**Re: wpd Sumac Ridge Incorporated (the "Applicant")
EB-2013-0442**

**WPD SUMAC RIDGE INCORPORATED (“wpd” or the “Applicant”) RESPONSE TO
SUPPLEMENTAL INTERROGATORIES**

22 **Response to Supplemental Interrogatories of Elizabeth Salmon**

**CROSS-SECTION DRAWING FOR 44KV
COLLECTOR DISTRIBUTION LINE**

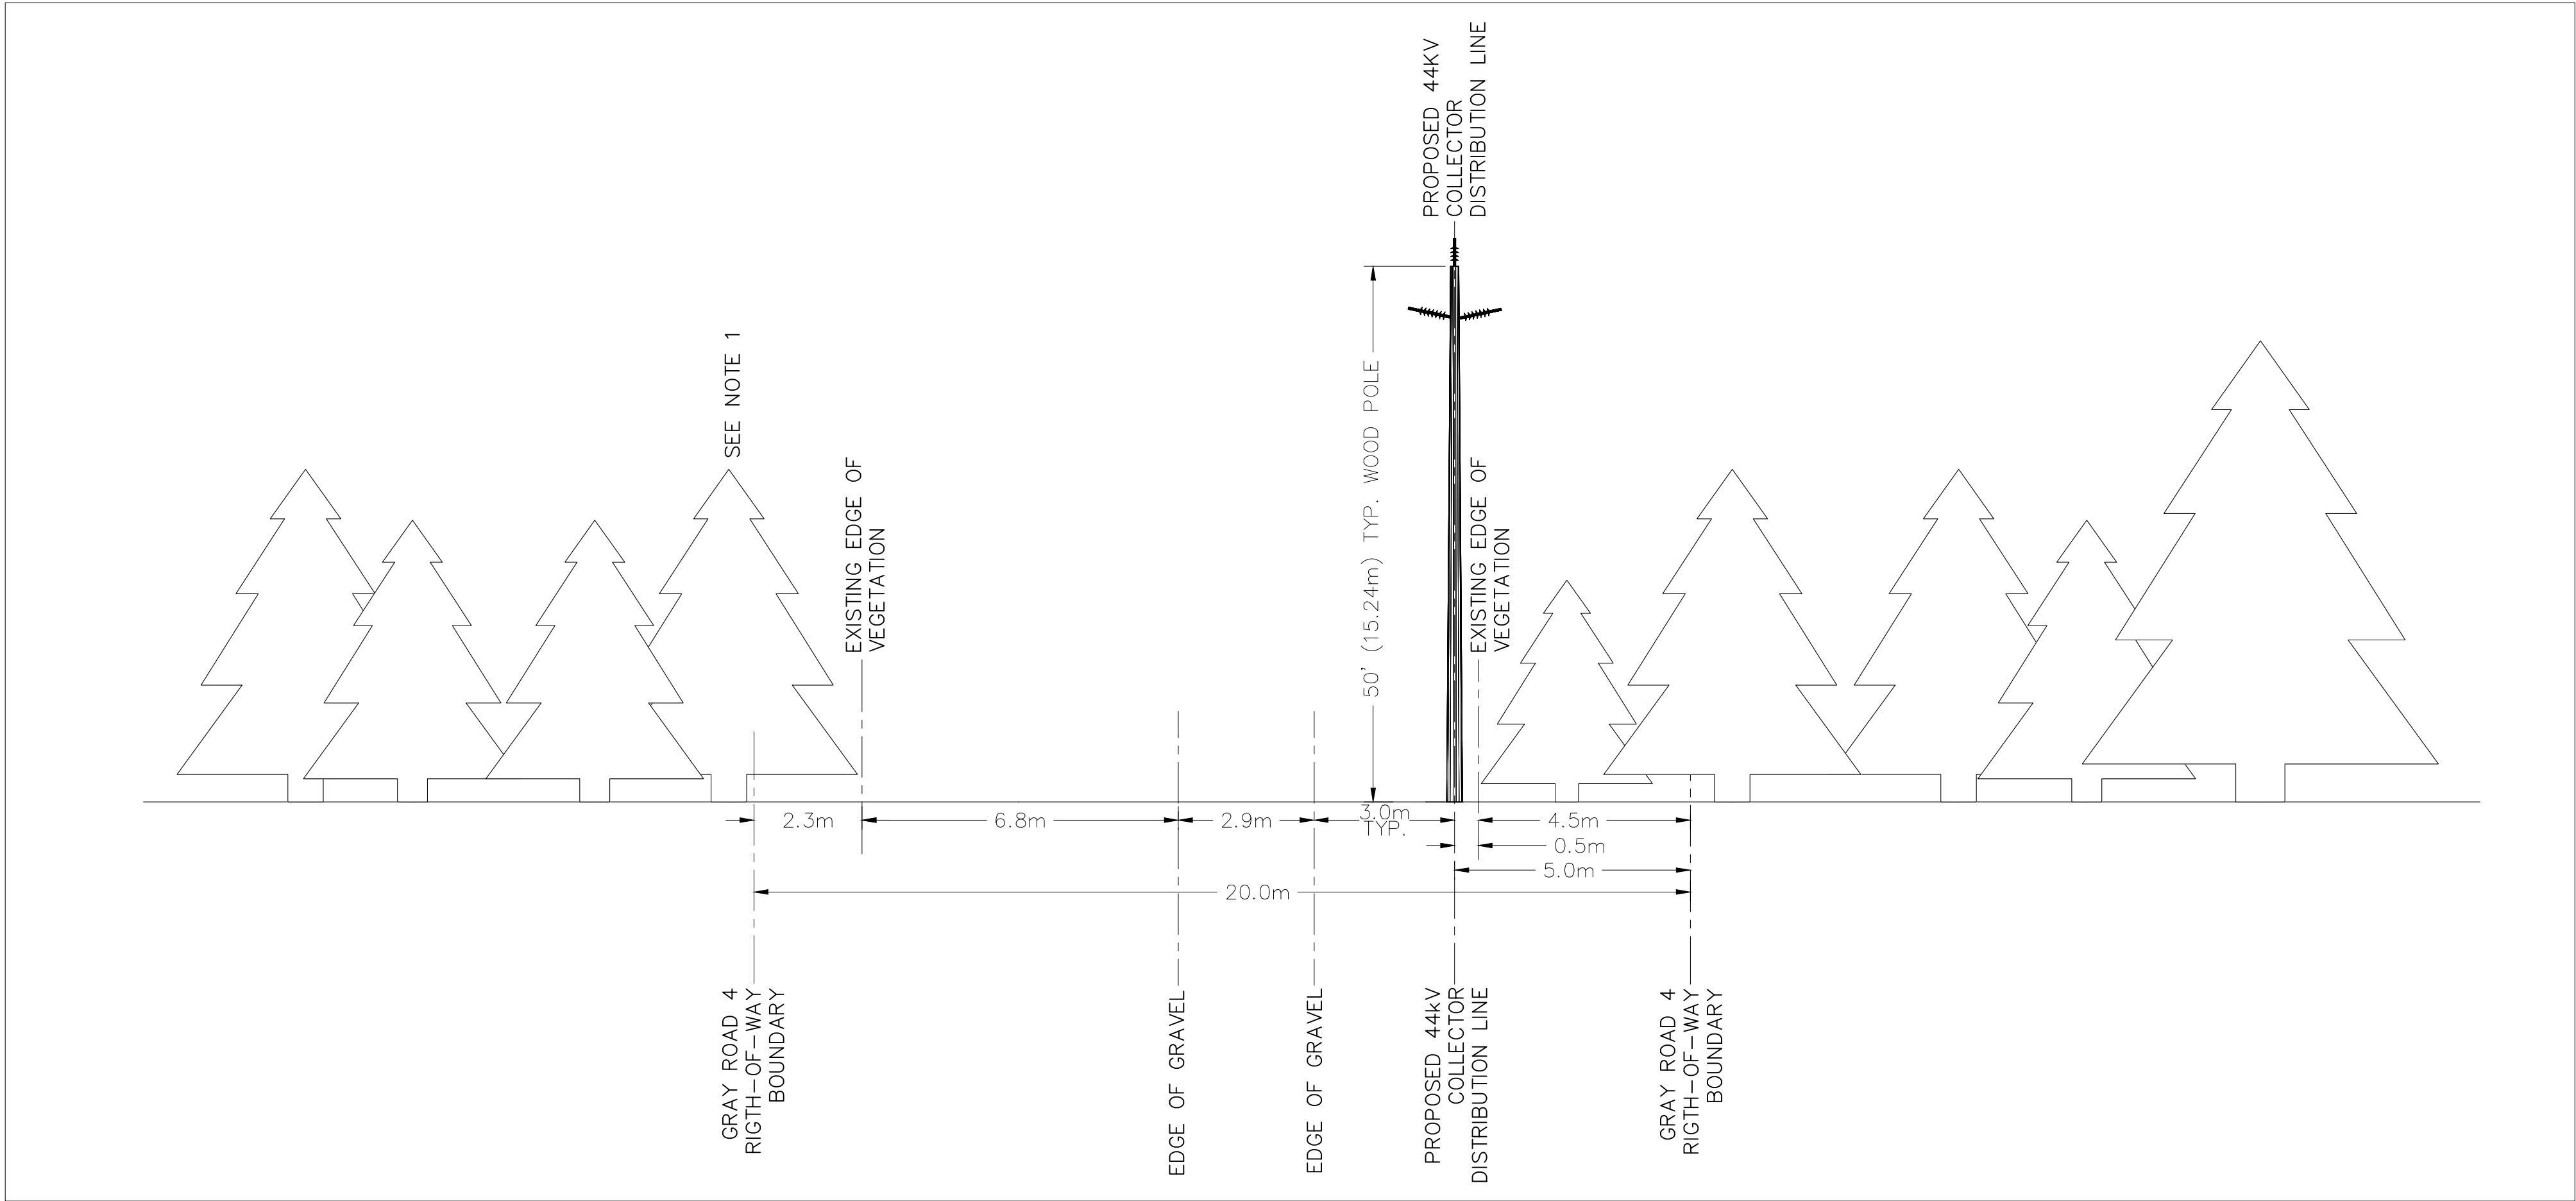
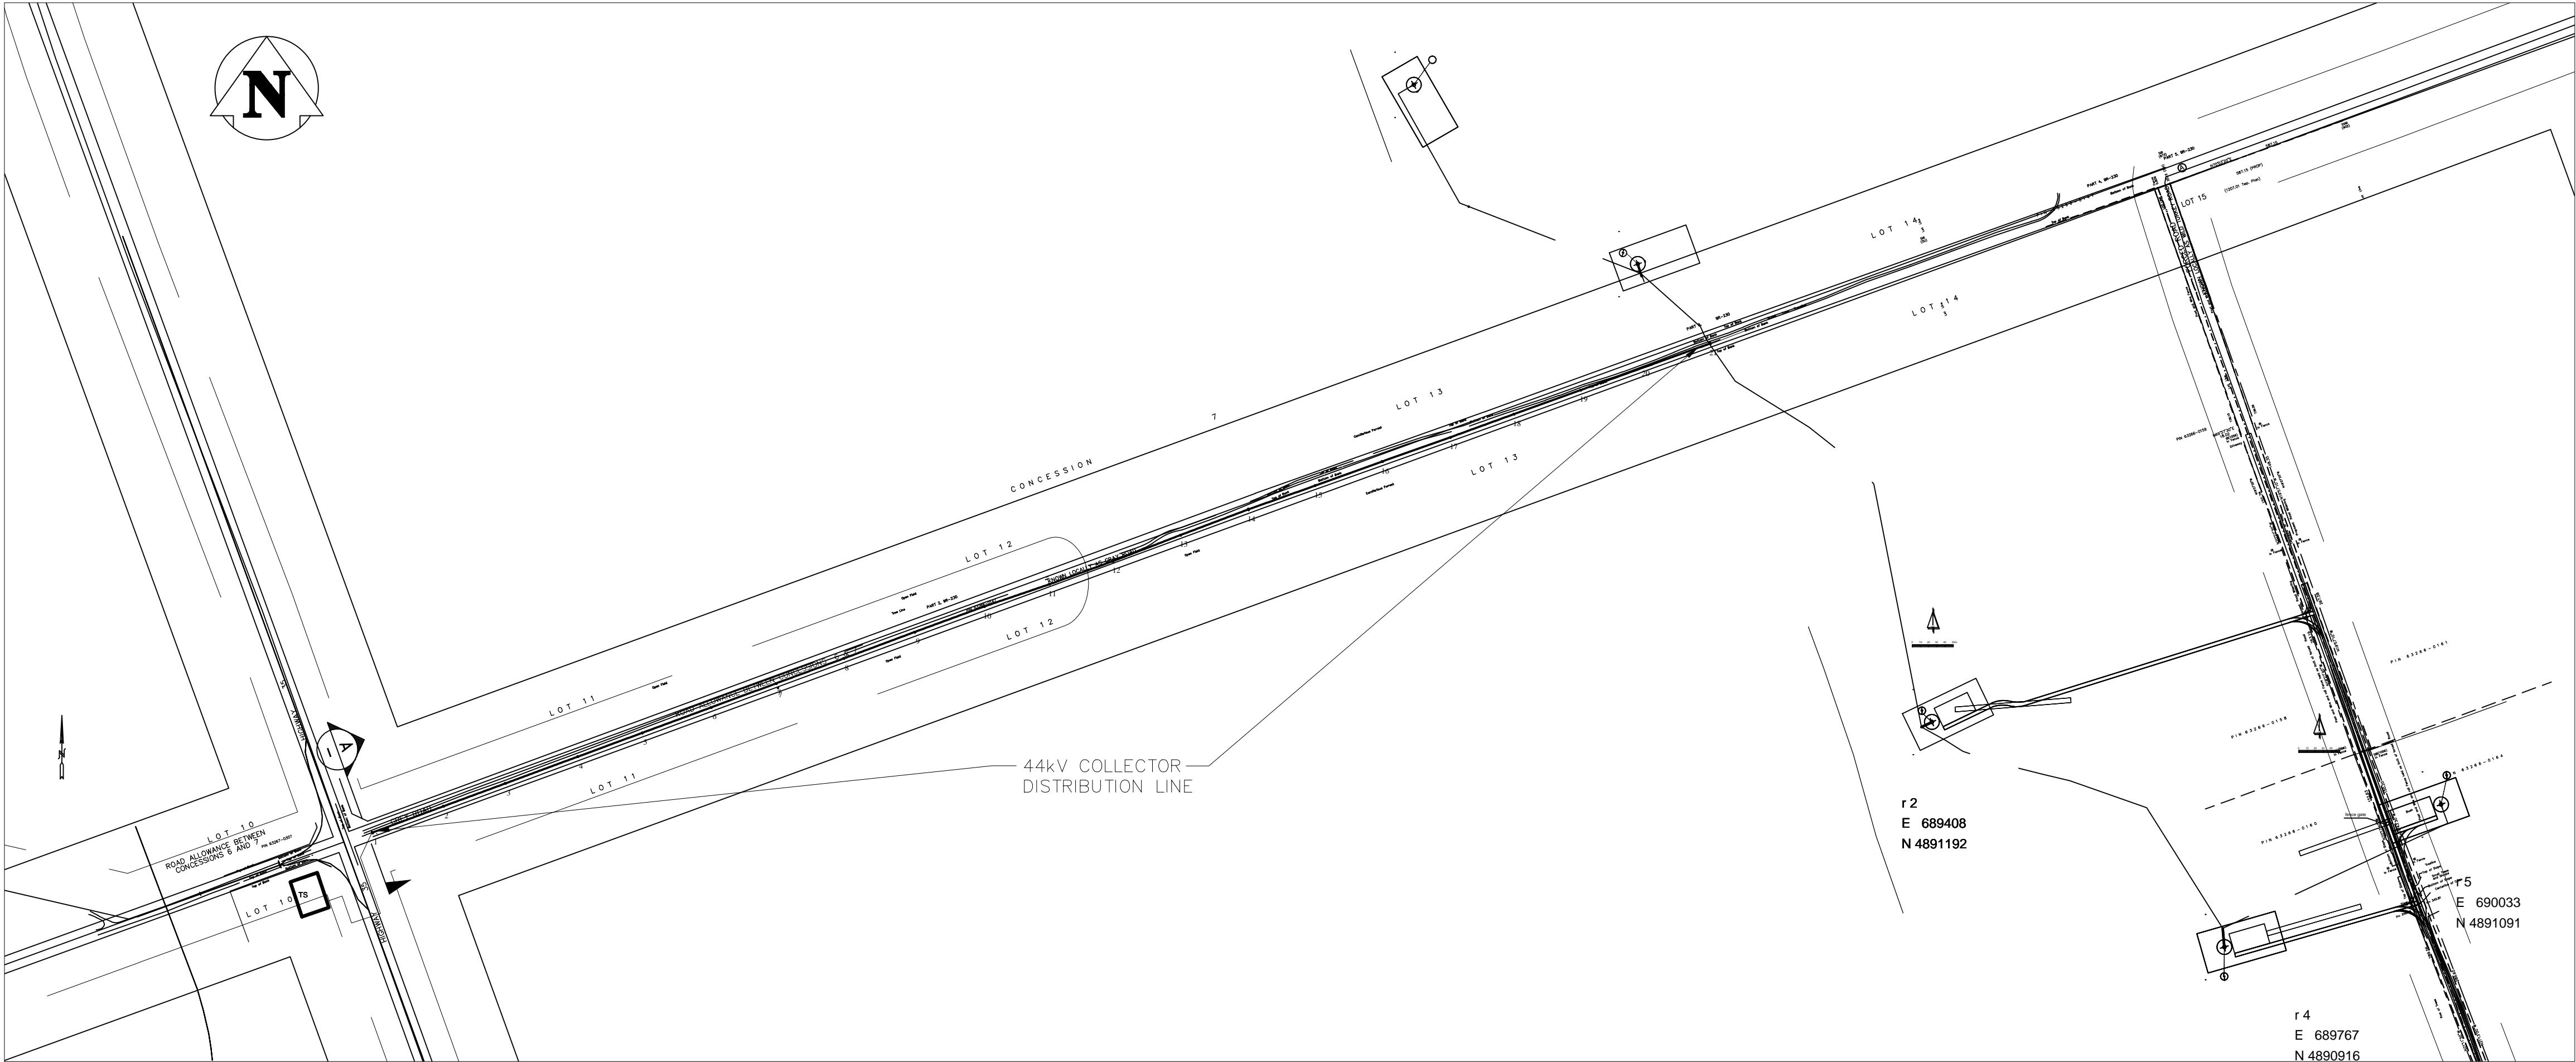
Interrogatory 13 (Paragraph 19): The Intervenor seeks clarification of missing, erroneous and/or incomplete information contained in the two cross section drawings provided by the applicant as follows:

(a) There is no indication what specific part of the road allowance Gray Road the smaller cross section diagram refers to. There is great variation in the environmental communities along the length of the unopened road allowance. Please clarify and correct this omission.

(b) The cross section map indicates the gravel to gravel edge of the Gray Road allowance is 2.9 m. Much of the road allowance contains little if any gravel. The width of Gray Road varies along its length, as does its soil composition. The width of 2.9 metres

17 (g) The cross section diagram indicates there is an undescribed 6.8 m zone to the
18 apparently north side of the gravel edge of the road allowance Gray Road. The
19 diagram suggests the 6.8 m is a clear zone devoid of vegetation. The unopened road
20 allowance Gray Road is heavily treed, including trees over 100 years old. Gray Road is
21 host to numerous other vegetative communities including shrubs, native groundcover
22 plants, grasses and vines. Please clarify and correct this omission.

23 (h) The cross section diagram indicates there is a clear zone of 3 m on the south side of the
24 road allowance Gray Road marking the existing line of vegetation to the south of the
25 hydro pole in the diagram. This is inaccurate. The south side of Gray Road is heavily

2 (i) Furthermore, the legend in the upper right hand corner of the diagram under Notes
3 states: *"Trees within 3 meters to the centre of the distribution line will be brushed before line*
4 *construction"*. The cross section diagram does not account for a 3 m clear zone on the
5 south side of the hydro pole. Please clarify and correct this omission.

9 (k) The second larger diagram which includes the unopened, unmaintained road allowance
10 known as Wild Turkey Road does not provide specific information on the collector
11 line planned to be constructed below and to cross this road allowance. Please clarify
12 and correct these omissions.

17 (n) This diagram shows an access road running parallel to the road allowance Wild
18 Turkey Road. This access road is not in the Sumac Ridge application which received
19 approval. There are no dimensions provided for this apparently new access road
20 including length, width and composition. The diagram suggests the collector line will
21 cross the new access road as well as the new access turn to Turbine #5 as well as crossing
22 Gray Road. The mapping information at this juncture supplied is confusing. This
23 confusion is compounded by what appears to be the original access turn to Turbine #
24 5 from Wild Turkey Road originally planned as the access route also included in the
25 diagram. Please clarify and correct these issues.

2 (a) The cross-section is a general representation of Gray Road in its entirety.

9 (e) The cross-section is a general representation of Gray Road in its entirety post-
10 construction.

12 (g) The cross-section diagram of Gray Road is a representation of Gray Road in its post
13 construction state.

14 (h) The cross-section diagram of Gray Road is a representation of Gray Road in its post
15 construction state.

16 (i) The cross-section diagram of Gray Road is a representation of Gray Road in its post
17 construction state.

8 (n) Please see revised cross-section, which is attached at Appendix "B".
